Millstone Nuclear Power Station, Unit No. 3
Relief Requests for the Second Ten Year Interval
of Inservice Inspection Program

Response to Request for Additional Information

Revised Relief Requests IR-2-25 and IR-2-26

FIG. IWB-2500-13 INTEGRAL ATTACHMENT WELD

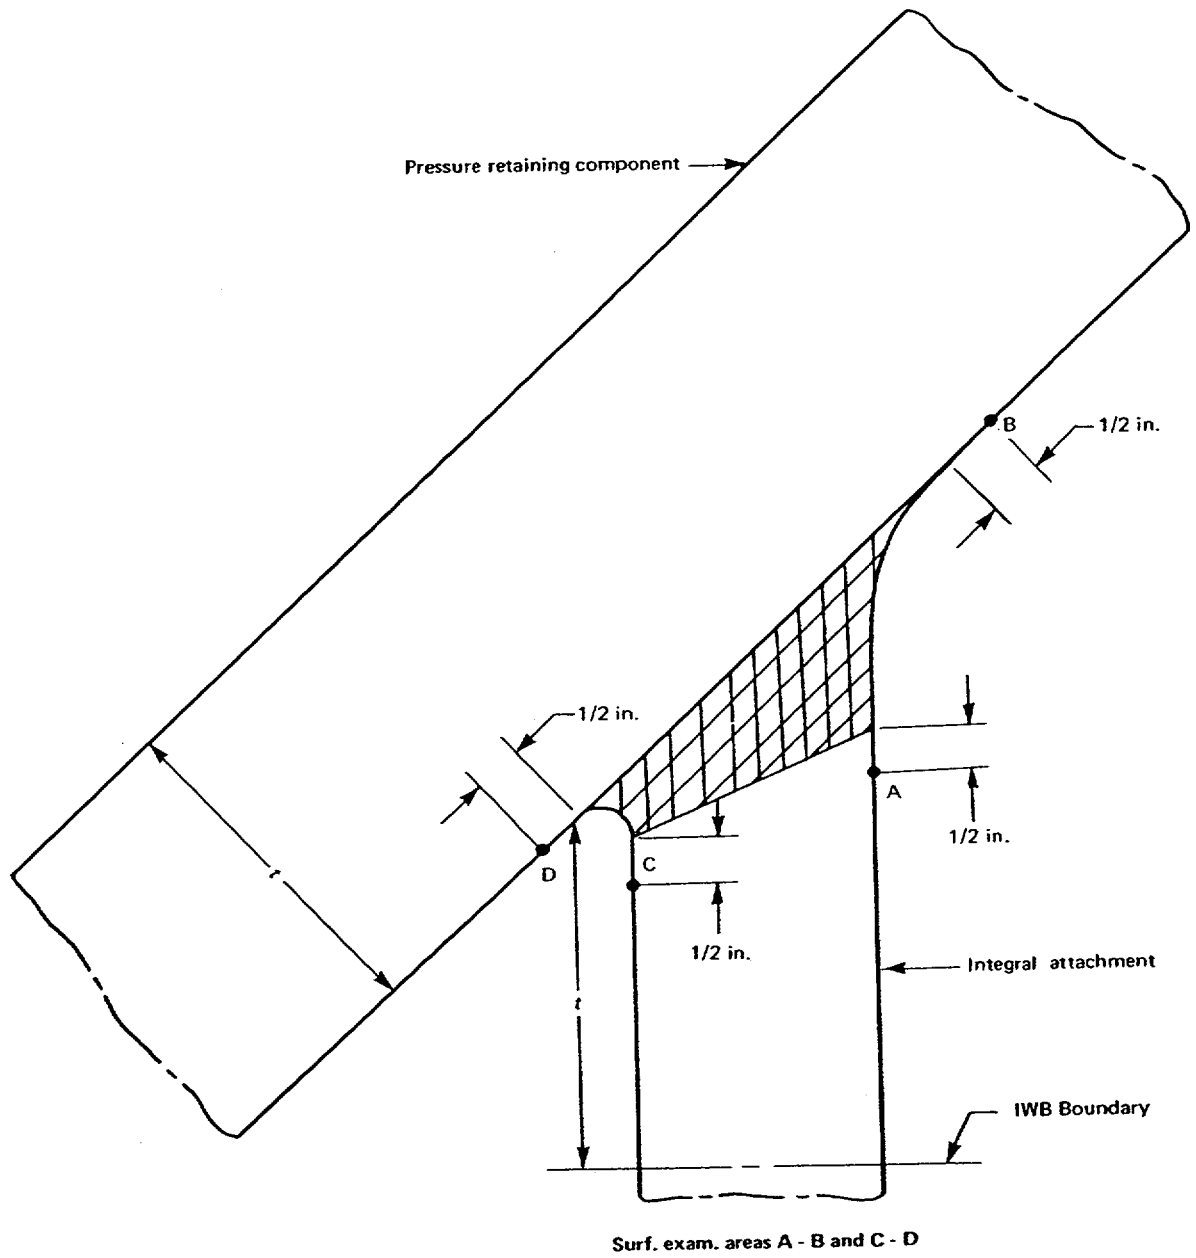
The licensee's proposed relief request is similar to Code Case N-323-1. This code case is listed in Draft Regulatory Guide DG-1112, "ASME Code Cases Not Approved For Use." The staff has accepted surface and UT examinations from the accessible surface. (See safety evaluation for Brown's Ferry Nuclear Station, Units 2 and 3, 2nd 10-year ISI interval dated June 19, 200, and Browns Ferry, 3rd 10-year interval, relief request 2-ISI-10, Revision 1, dated February 4, 2002)

Pursuant to 10CFR50.55a(g)(5)(iii) relief is requested from performing the surface examination on the inaccessible portions of the pressurizer support skirt to vessel shell weld. The inaccessible portion corresponds to the interior surface C-D as shown in Figure IWB-2500-13.

Geometric configuration of the support skirt-to-shell weld limits the surface to be examined to the one accessible side, corresponding to examination surface A-B, as shown in Figure IWB-2500-13. The attached sketch shows the interior portion of the subject weld to be inaccessible to a meaningful surface examination. Also, high radiation levels within the support skirt would result in an estimated personnel exposure of an additional 7.2 Rem to complete the scaffolding, insulation removal/replacement, weld preparation and best effort examination.

Relief Request IR-2-26 has been revised to add an ultrasonic examination. See revised relief request IR-2-26 in Attachment 2 which supercedes the original and addresses this question. Revision bars are included in the left margin to indicate the changes from the original submitted on September 27, 2001.

- A The subject weld will receive a surface examination of the accessible exterior weld surface A-B as shown in Figure IWB-2500-13, in accordance with ASME Section XI (IWB-2500-1).
- B. The subject weld will receive a best effort UT examination to achieve the maximum practicable coverage of the required examination volume as depicted in figure IWB-2500-13. This examination will be performed from the outside surface of the skirt attachment.

Based on the surface examination performed on 100% of the exterior weld surface A-B as shown in Figure IWB-2500-13 and a best effort UT examination from the outside surface of the skirt attachment, DNC believes the proposed alternative will provide an acceptable level of quality and safety by providing reasonable assurance of structural integrity of the subject weld.
